Access Compliance Report

Public Rights-of-Way

(Curb Ramps)

| Intersection ID: 43367 | Main Street: ROUDA_LN | Cross Street: SIMONTON_DR | Location: | E |

| ADA ID: ACA592454627 | Ramp Type: PerpDiag | Initial Pass/Fail: Fail | Overall Compliance: No | Severity Score: 25 |

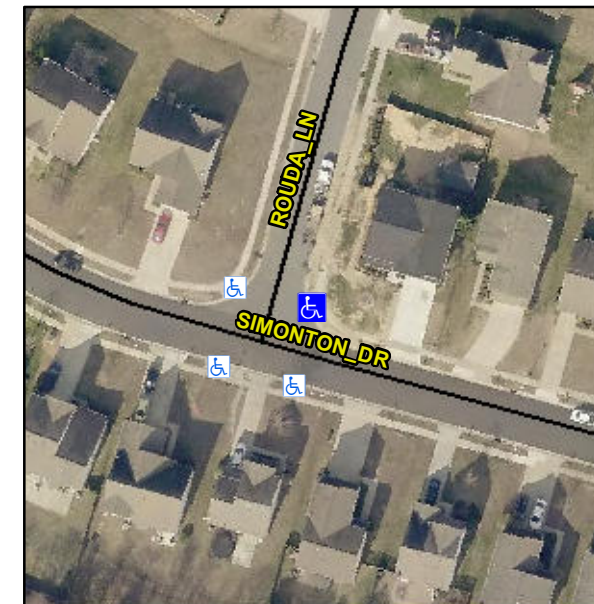
Not Found, R304.2.2, R304.5.3

| Compliance | Description | Data | Compliance | Description | Data |
|------------|-----------------------|-------|------------|-----------------------------|-------|
| N/A | Ramp Length (in) | 48.0 | No | Ramp Slope (%) | 9.7 |
| Yes | Ramp Width (in) | 48.0 | No | Ramp XSlope (%) | 5.6 |

Remove & Replace Curb Ramp With Two New Directional Ramps or Equivalent.
